ADDENDUM 01

Project: Upstate – Palmetto Villas Crawl Space Repairs

JCS Project #: 18108

Date: 4/18/2019

VILLA #5 CRAWLSPACE
SCALE 1/8" = 1'-0"

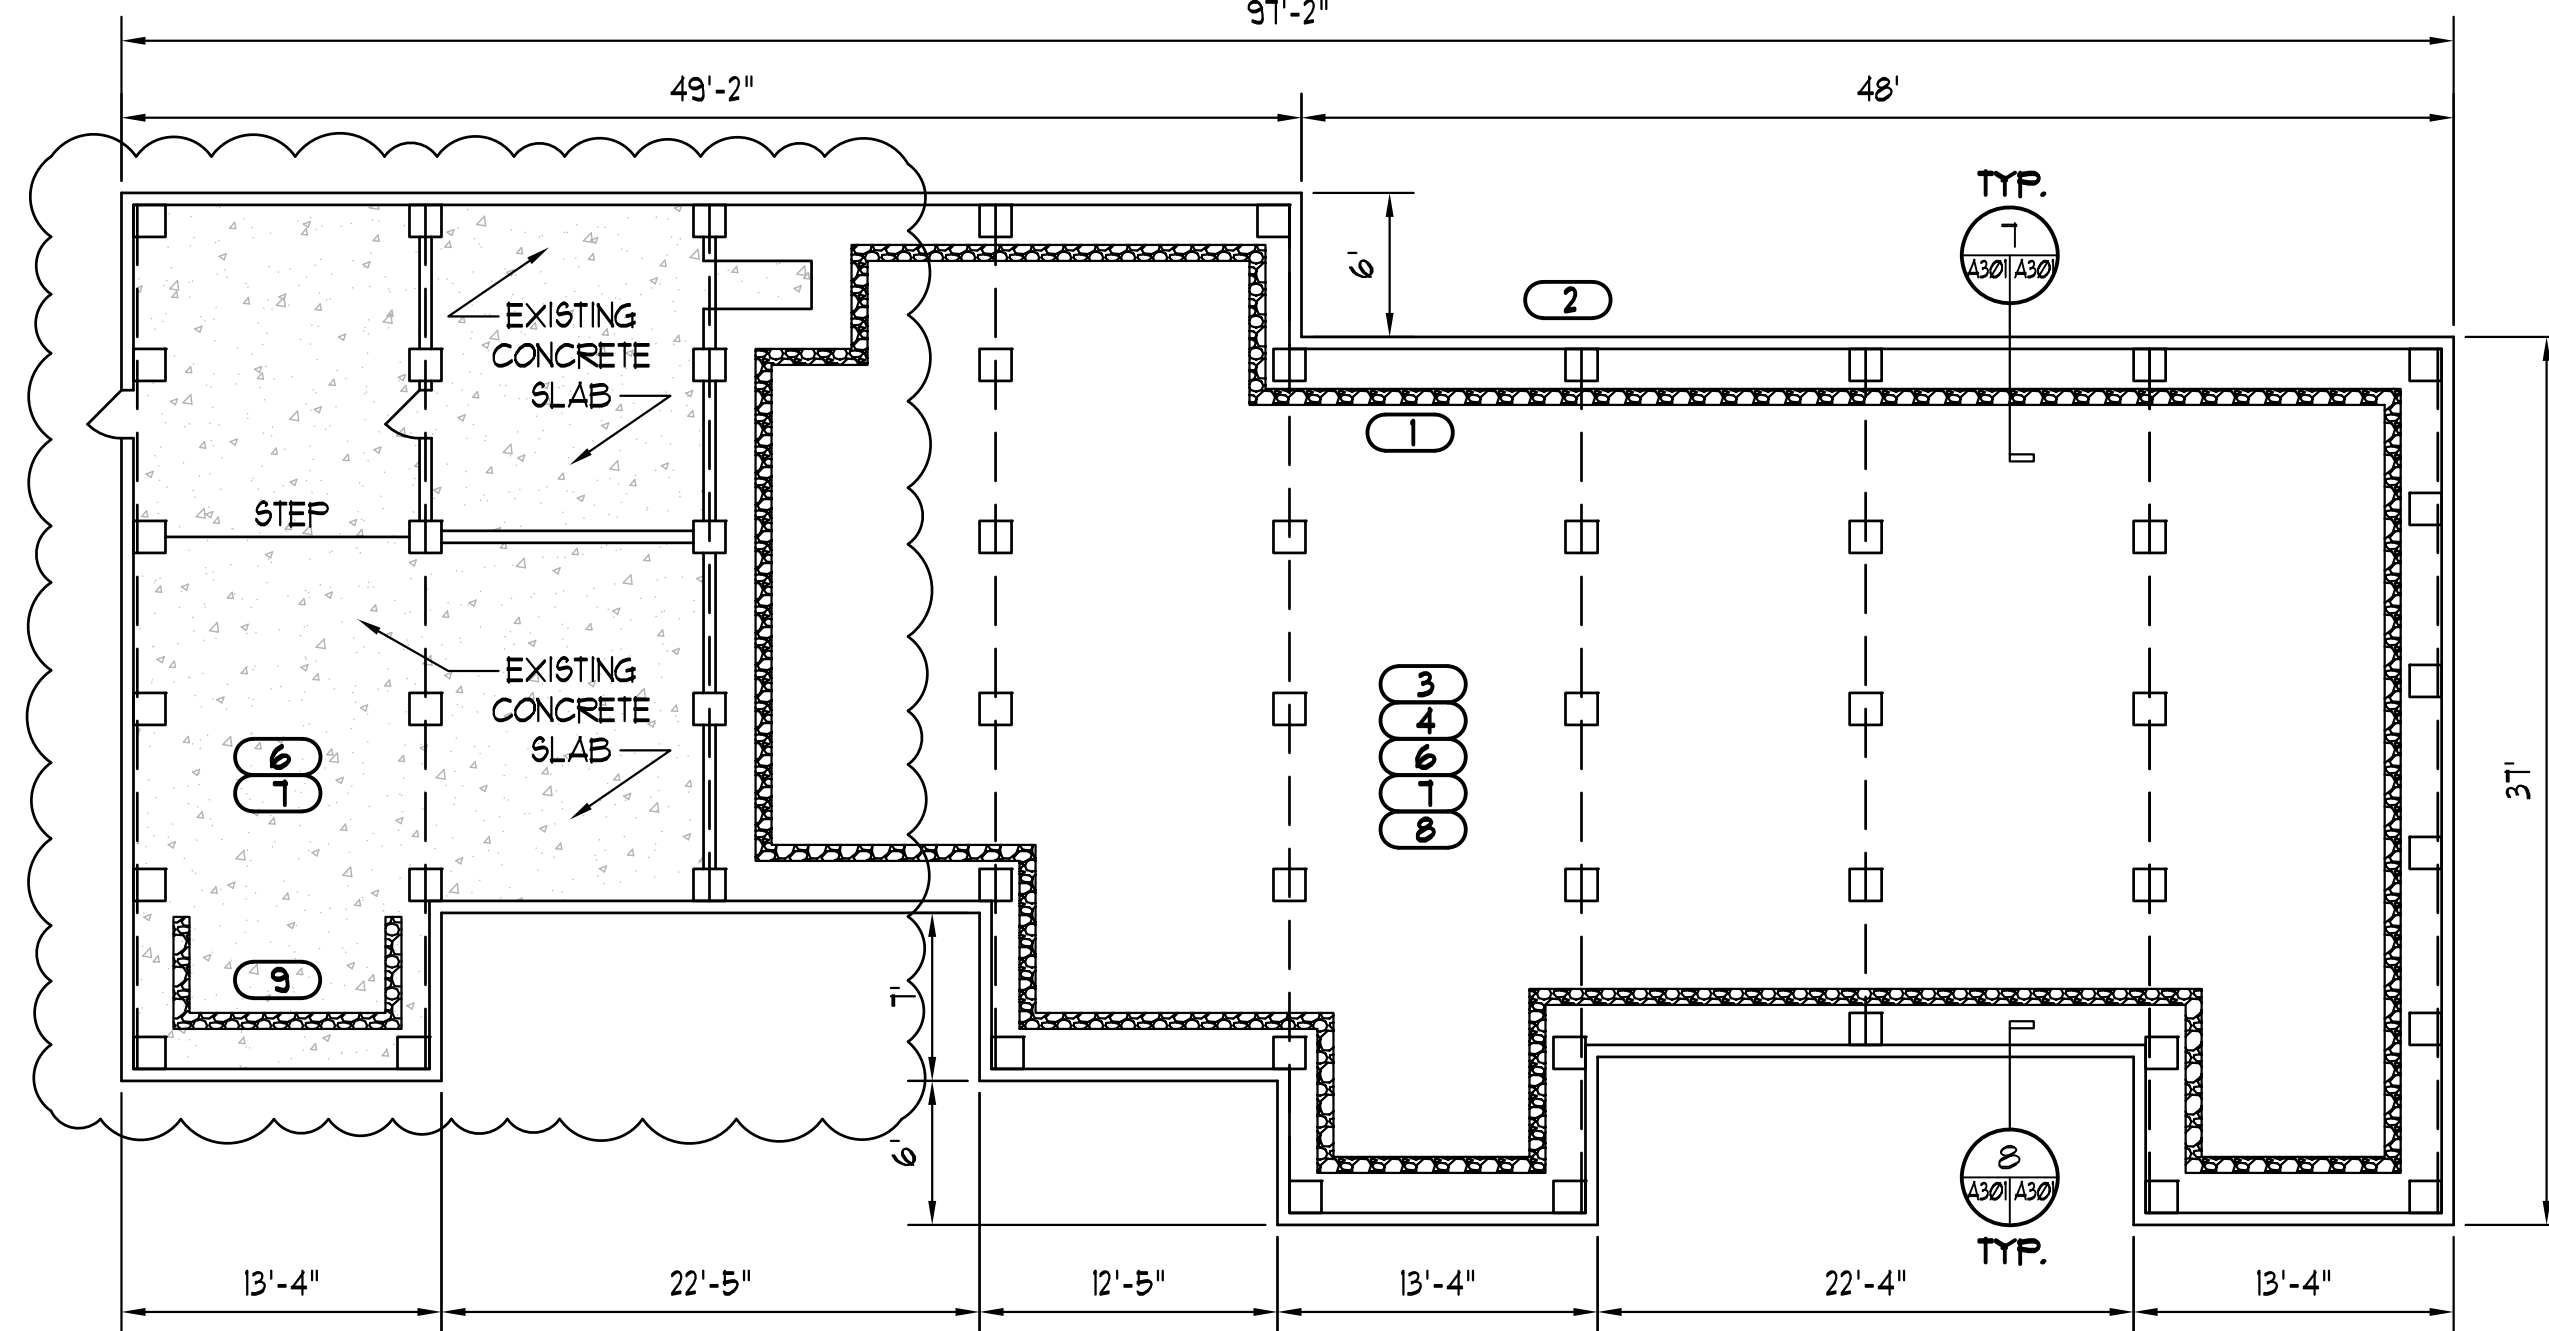
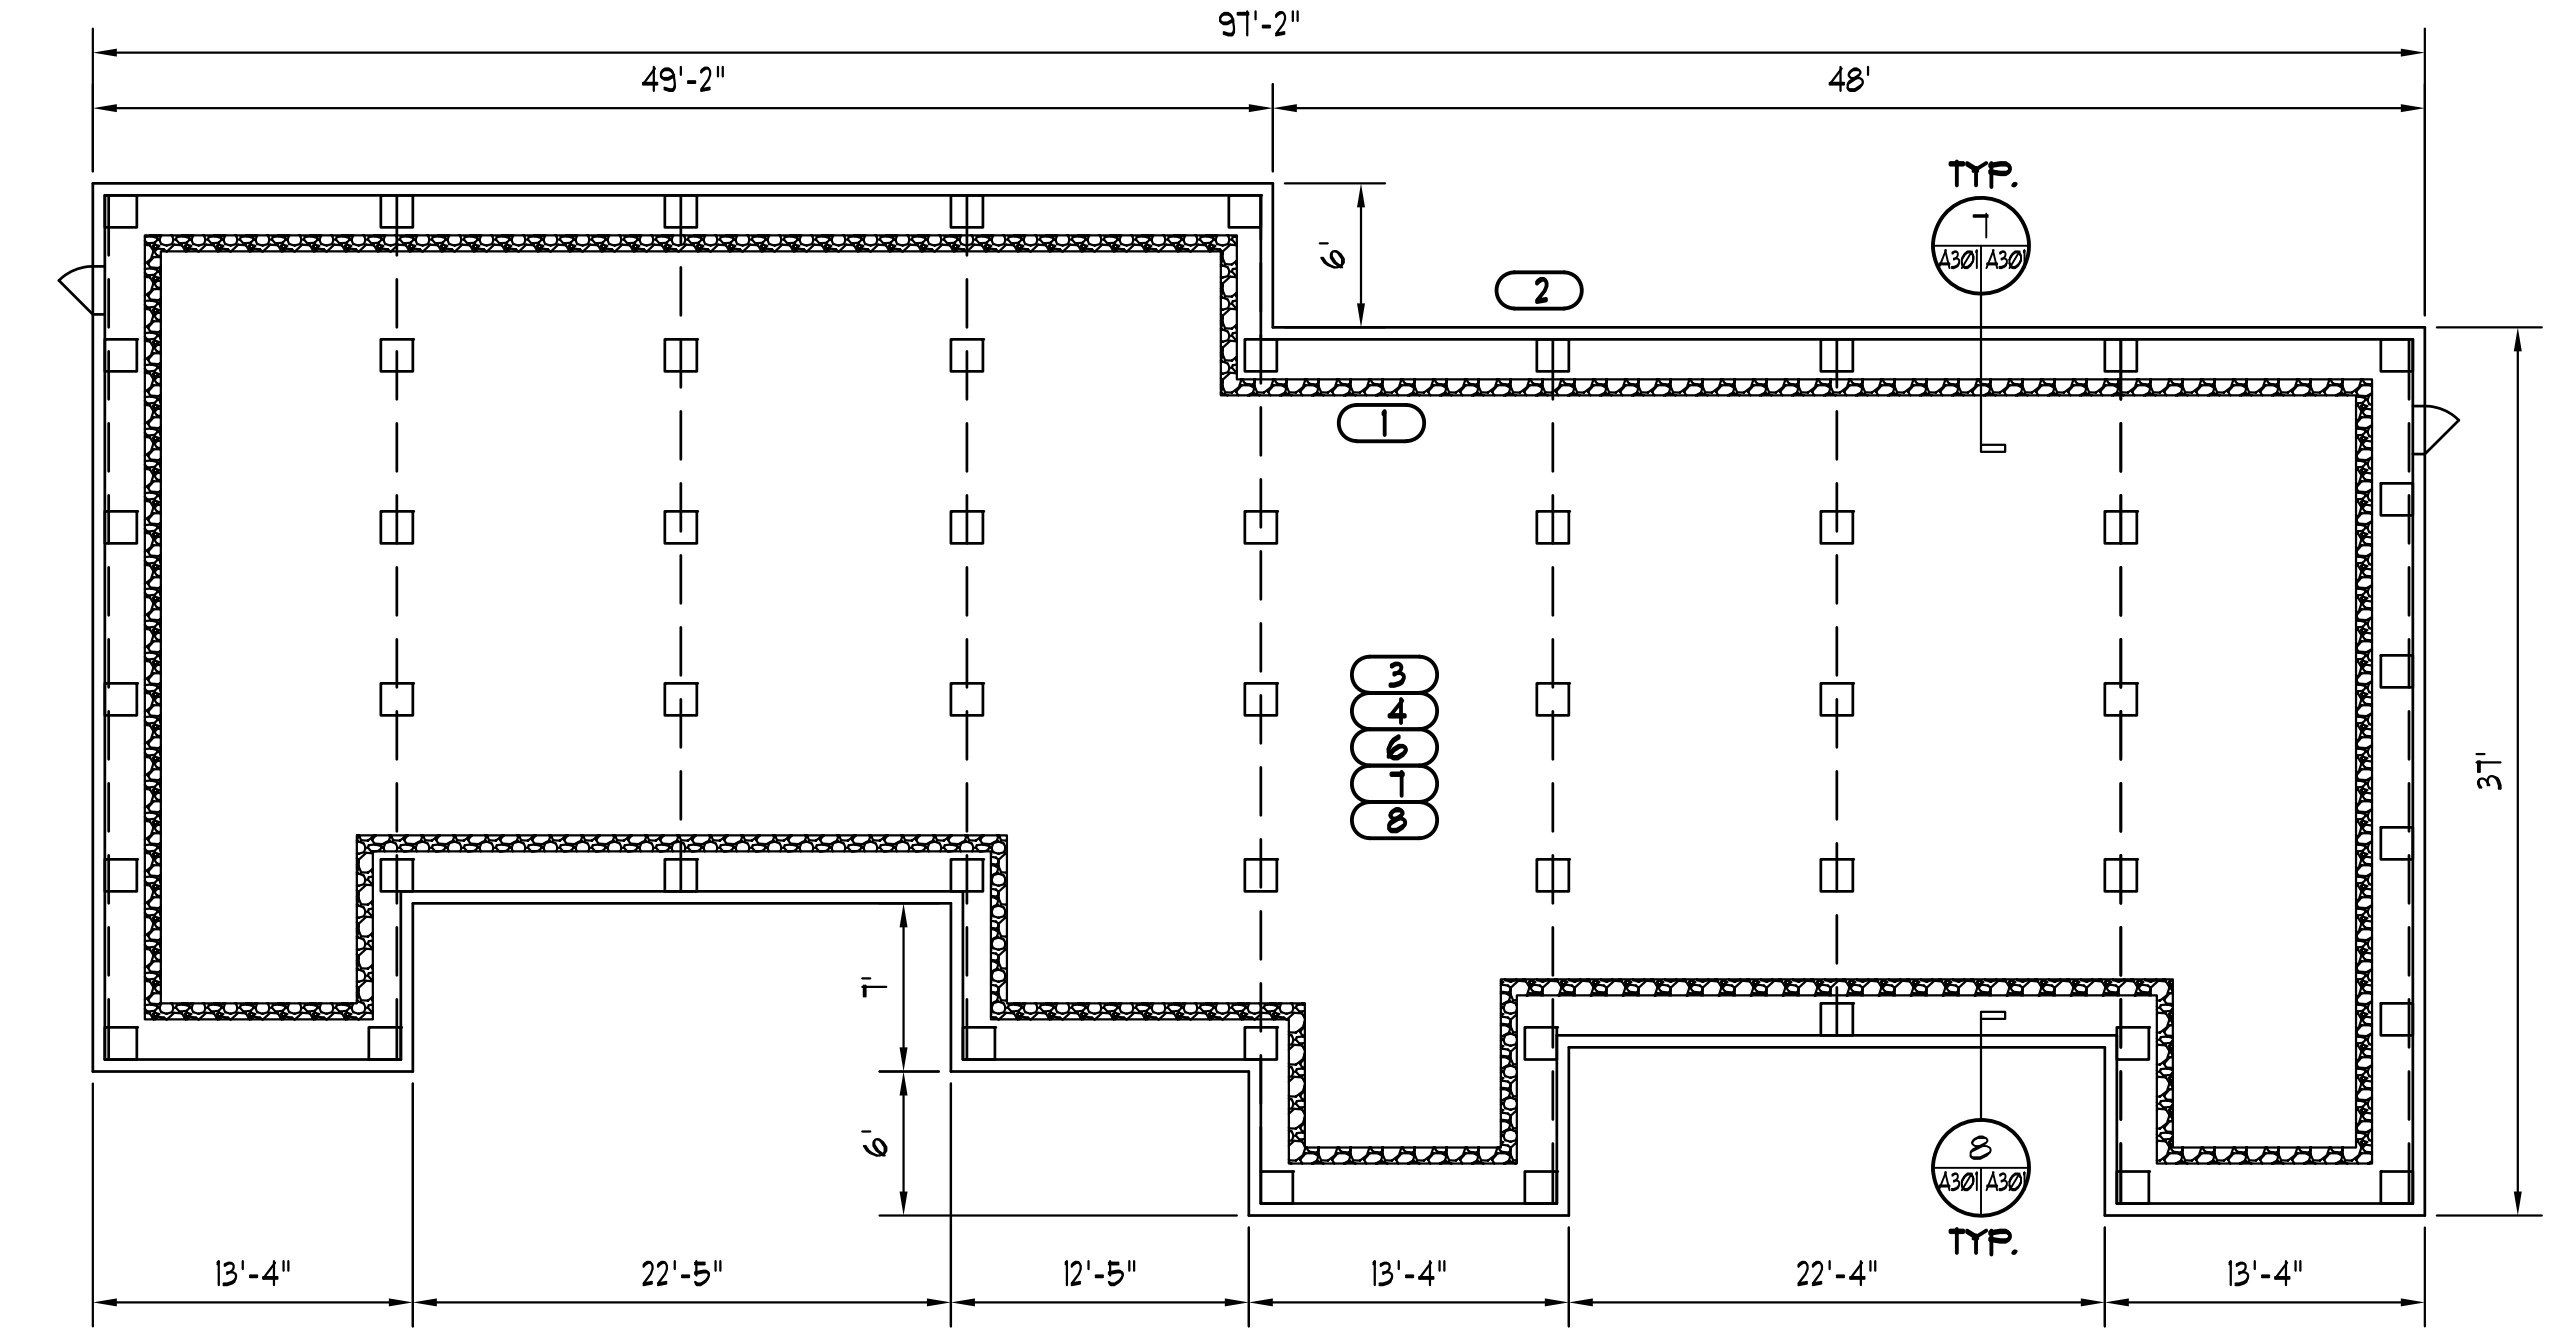
1. **Sheet A301, Crawl Space Plans and Details.** See attached revised sheet A301.
